MAINE TURNPIKE AUTHORITY

ADDENDUM NO. 2

CONTRACT 2016.02

GRAY INTERCHANGE

SUBSURFACE WASTEWATER DISPOSAL PLAN

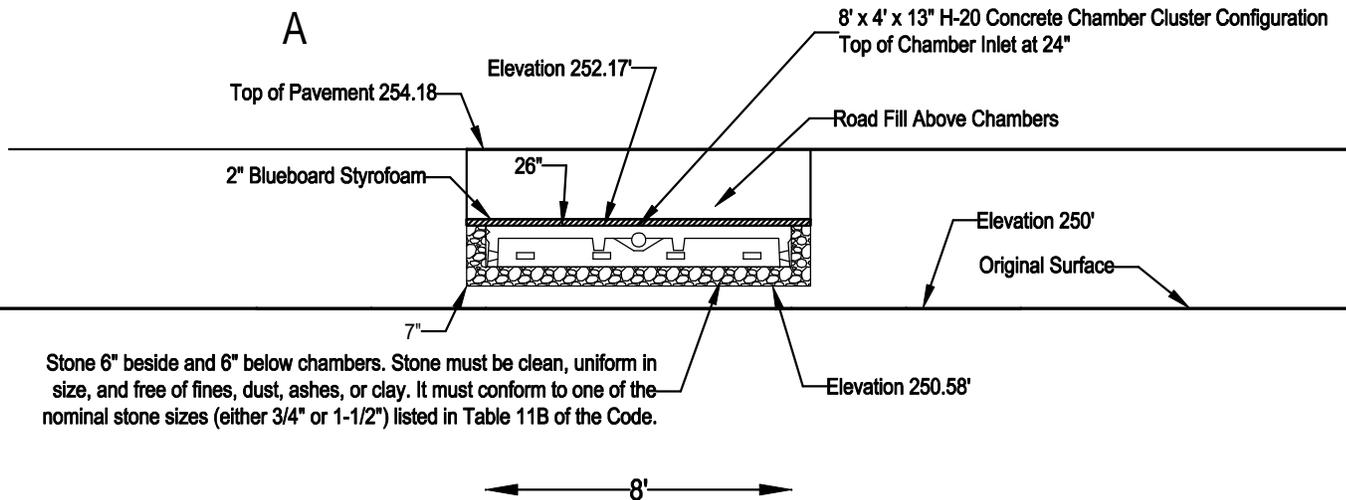
In the Contract Documents, Part IV – Appendices, Appendix A – Subsurface Wastewater Disposal System Application, Subsurface Wastewater Disposal System Application shall be **DELETED** and **REPLACED**. The revision noted “H-20” for the chamber strength. Revised page sheet included in this addendum.

9 - 8' x 4' x 13" H-20 Concrete Chambers
 1 rows X 9 units long - [8' x 36']

Date: JAN 04 2013	Project No.: 1370-001
Attention: Scott A. Warchol (swarchol@maineturnpike.com)	
Re: Laboratory Testing Exit 53 Bridge Rehabilitation & Interchange Improvement Project

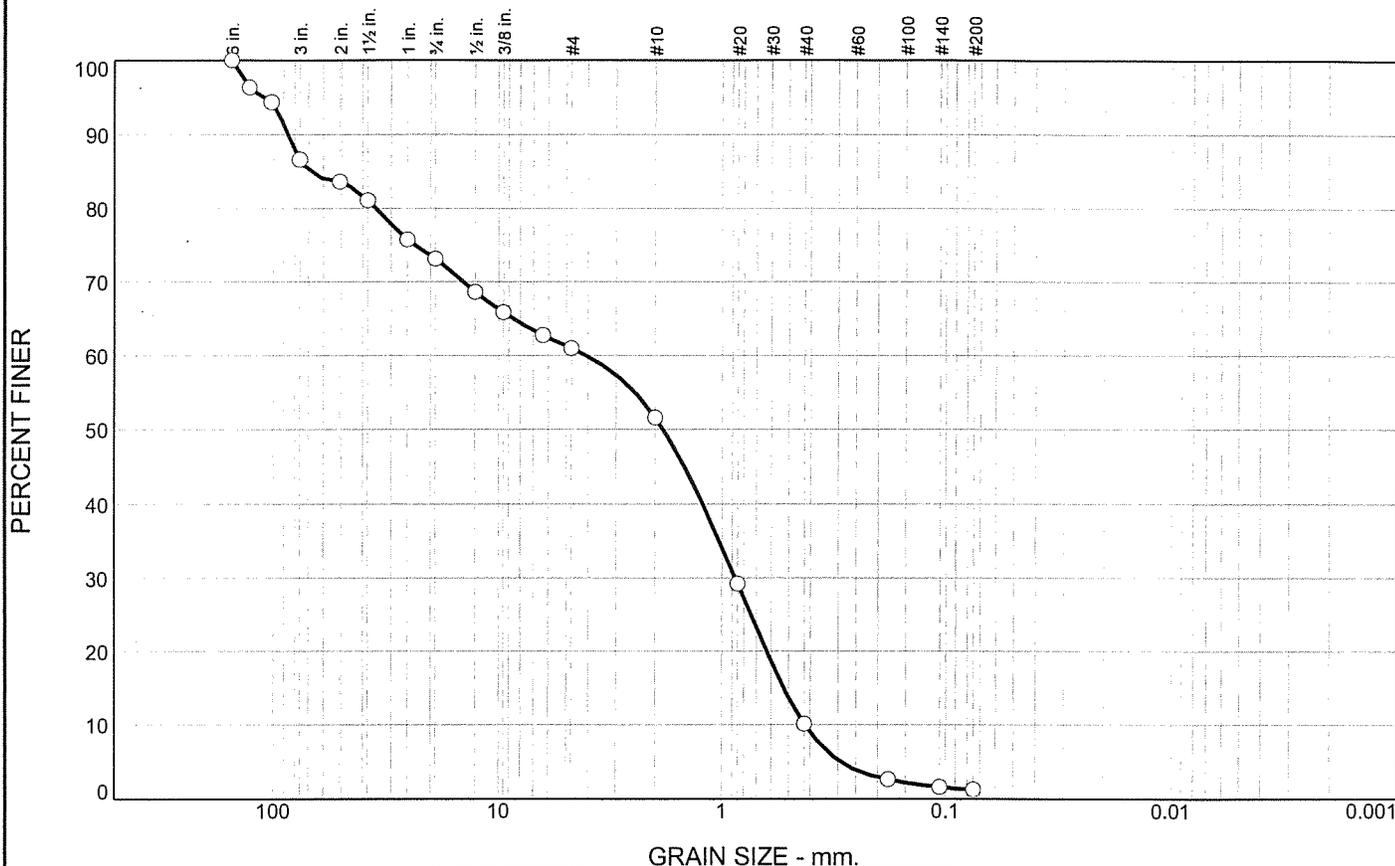
- 16) Question: Is it possible to supply us with the gradation and proctor test results for the preload material that was used from the Bennett Rd. Pit?

Response: The gradations from the Bennett Road pit are attached and no proctor test information is available. The previous construction of the southbound ramps was constructed from material from the Bennett Road pit and other material sources and the locations where the differing material was placed was not documented. This information is being provided for information purposes only and the bidders should act accordingly as Maine Turnpike Authority provides no guarantee on the material that was placed.

STRUCTURE NO. 40 TURNPIKE UNDER
 GRAY INTERCHANGE - RAMP A
 STA. 3168 + 50.00
 GENERAL PLAN AND ELEVATION

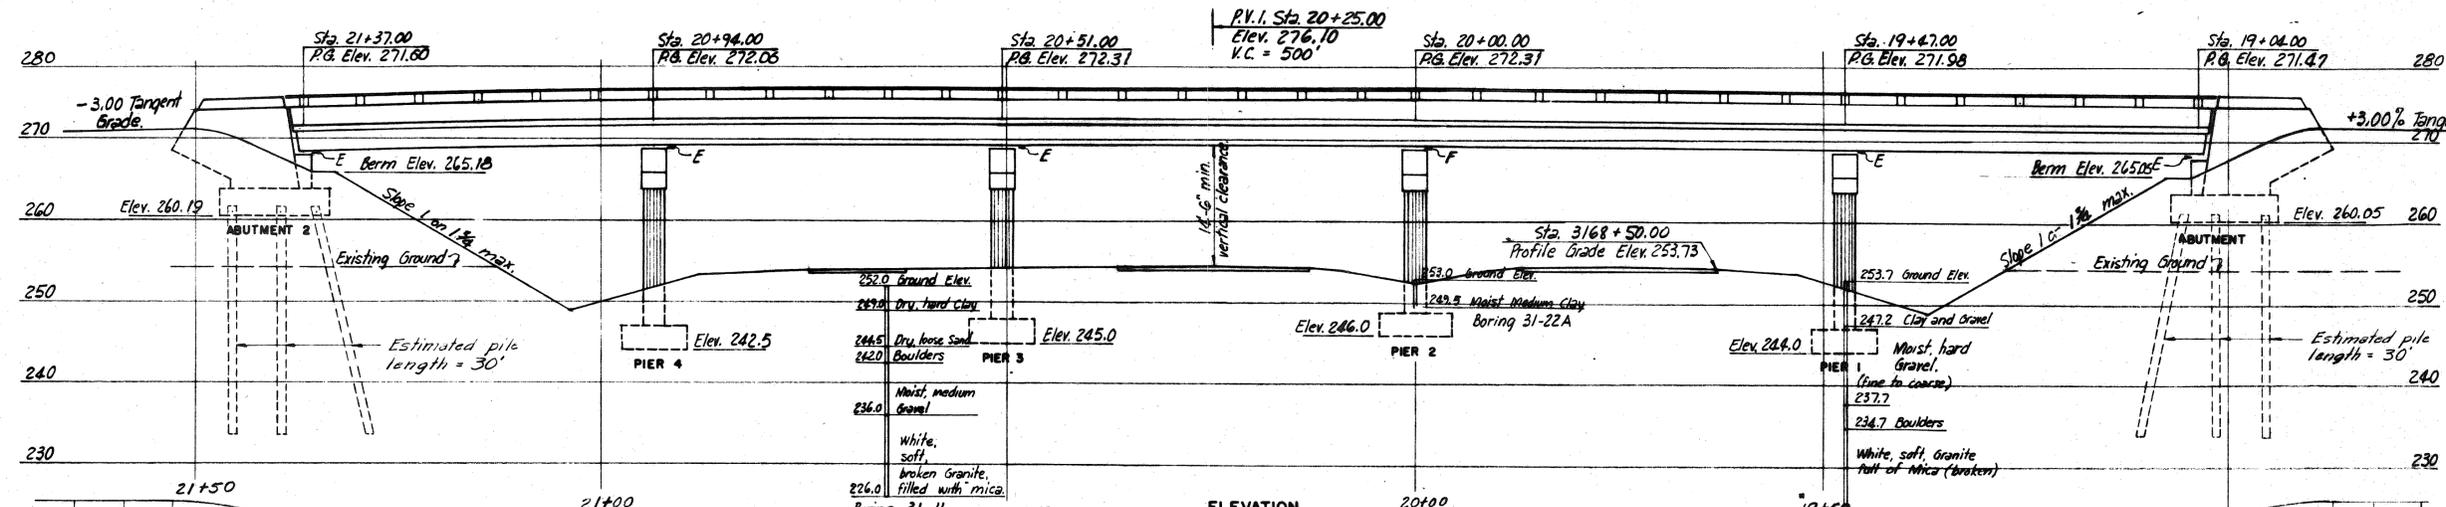
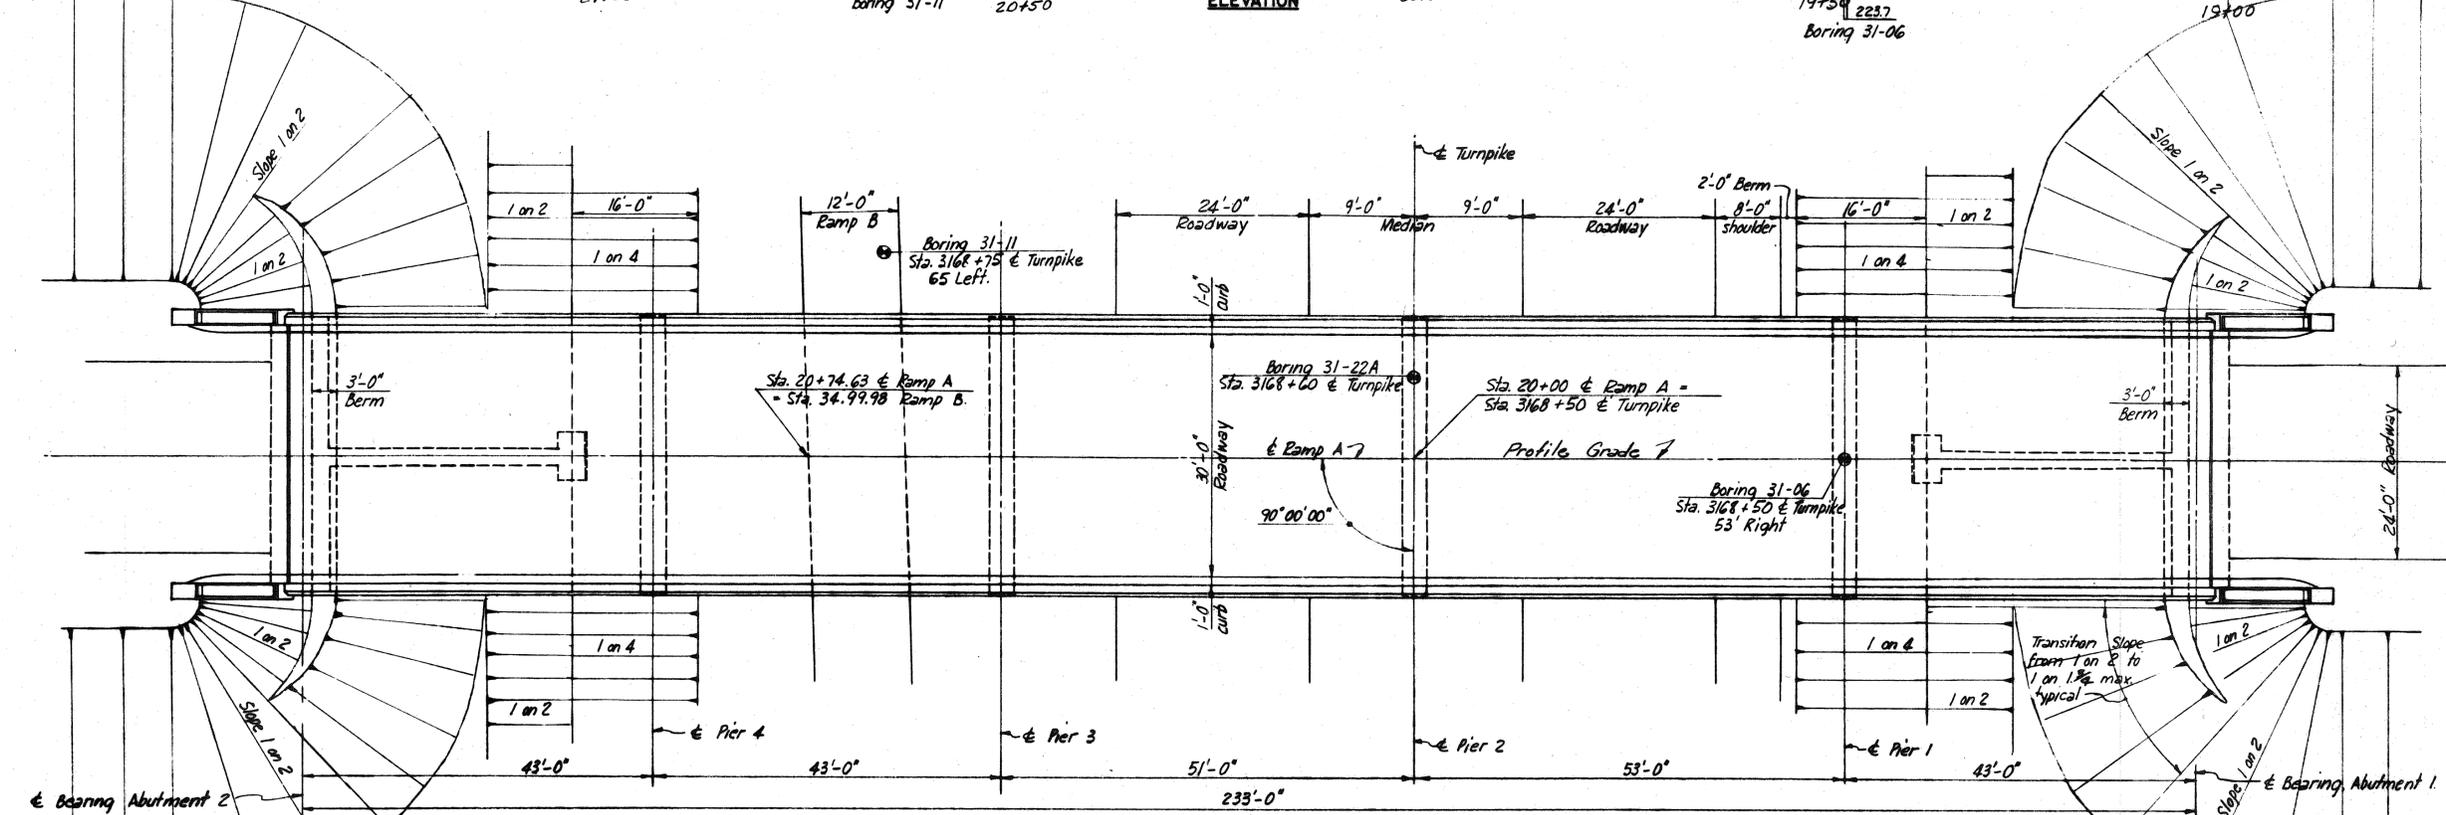
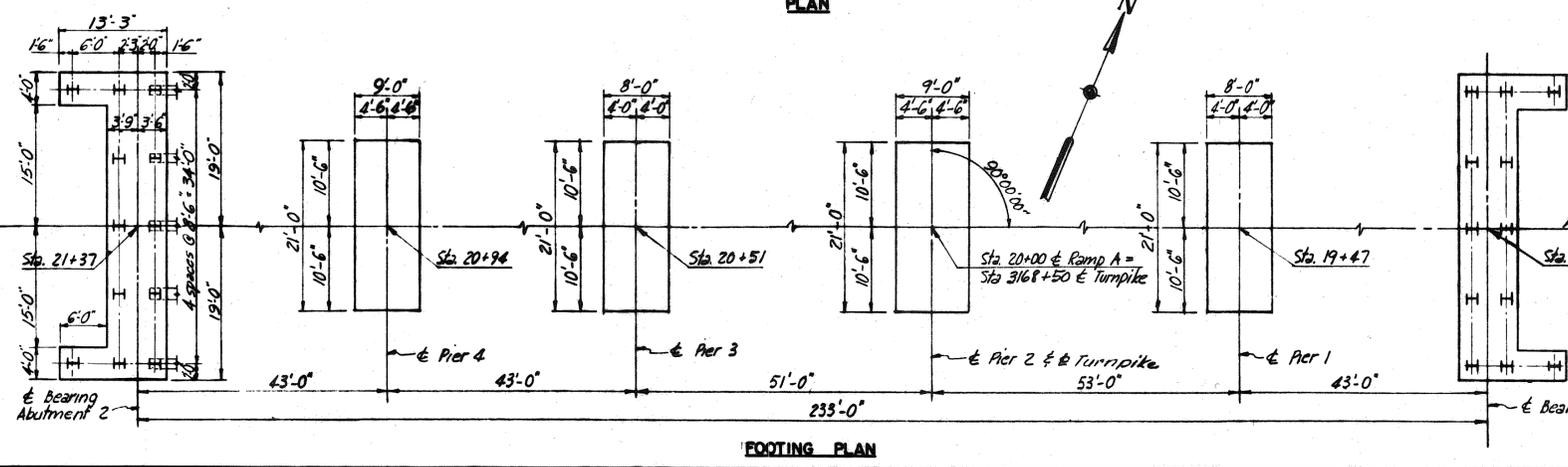
- 12) Question: I only saw two plan sheets included in the plan set for the southbound ramp A underpass bridge removal. Can MTA provide an existing plan set for this bridge?

Response: Existing plans (4 sheets) for the Ramp A Underpass Bridge are included in this addendum.
- 13) Question: There are two bid items, 515.201 & 516.202 with the same description, Clear Protective Coating for Concrete Surfaces. There is no 516 specification. Please clarify.

ADMIN BUILDING
LIGHTING &
POWER PLANS

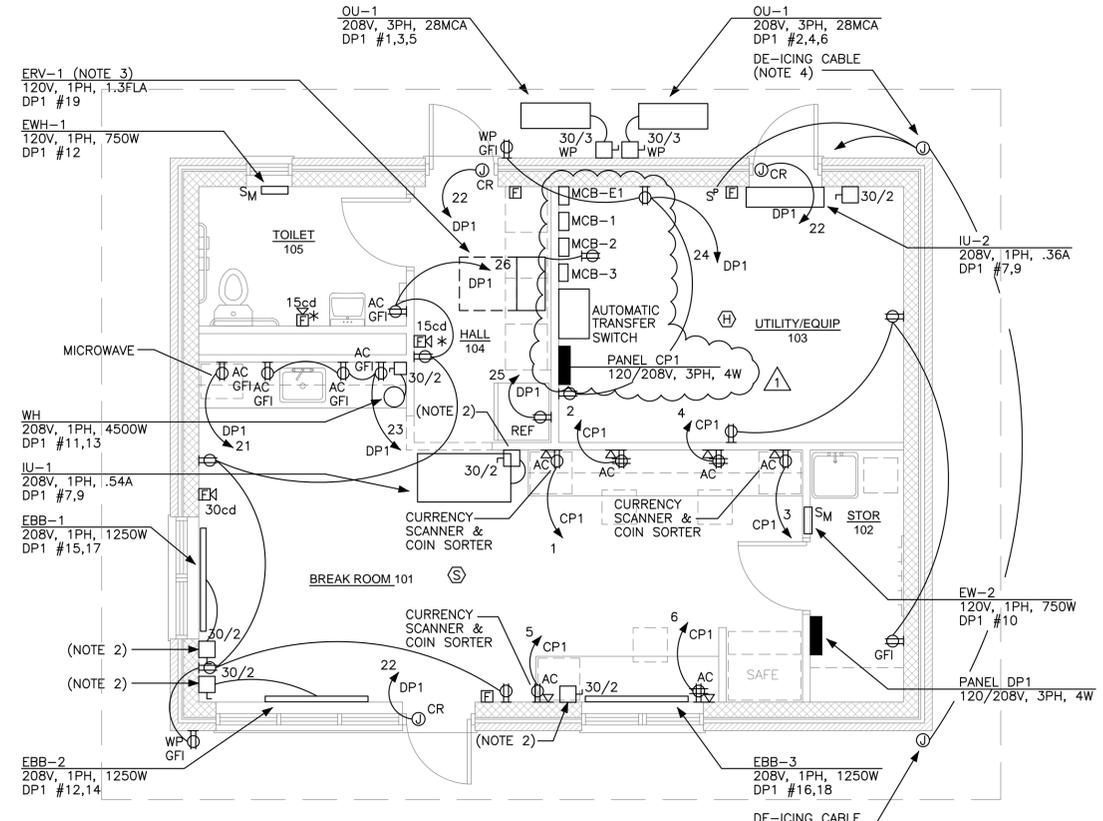
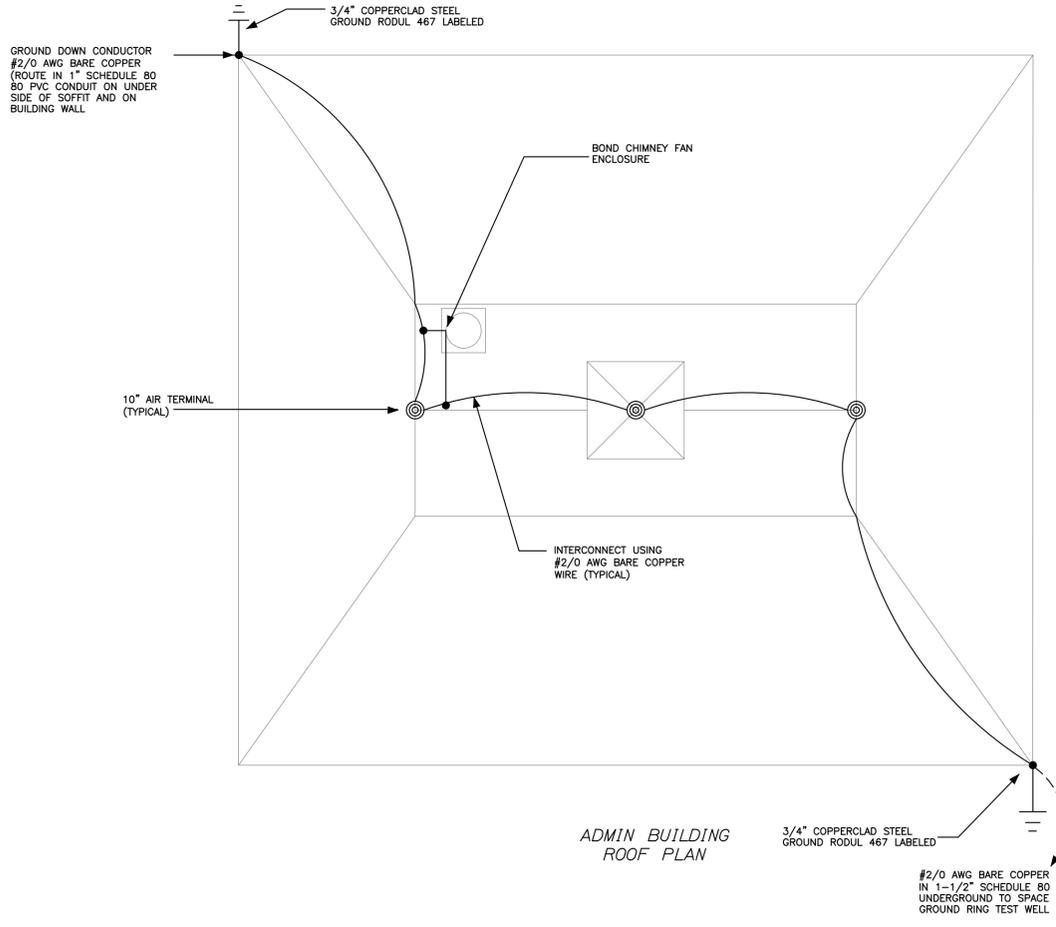
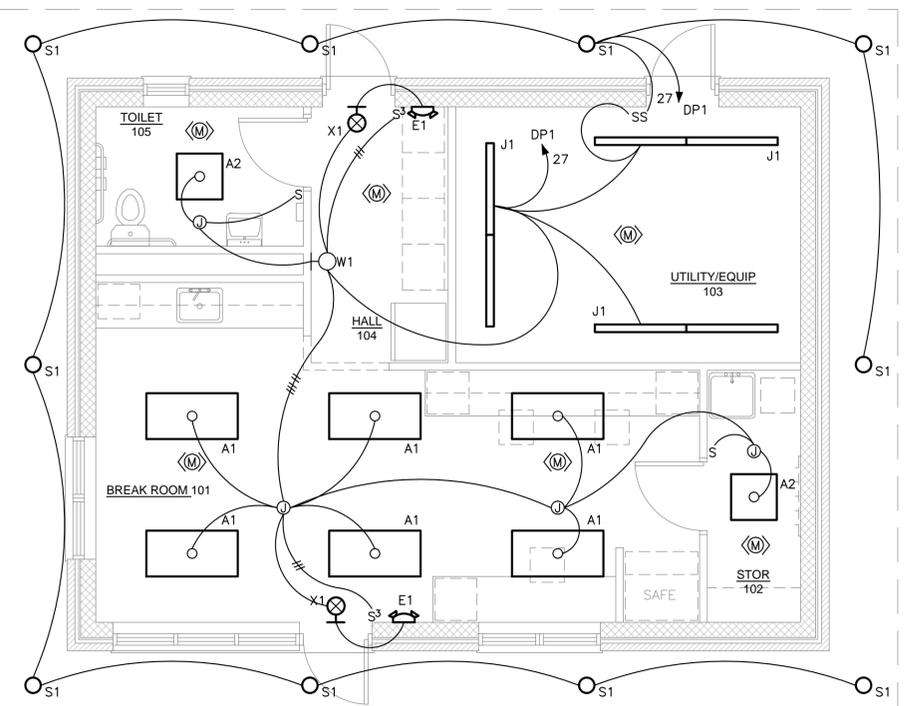
18) Question: Light fixture W1 was not identified on the plans. Please clarify.

Response: W1 is a wall mounted light (at 6') - ASL- model # CKS-18.8W-3000K-DV-FPA-SWA or equal.
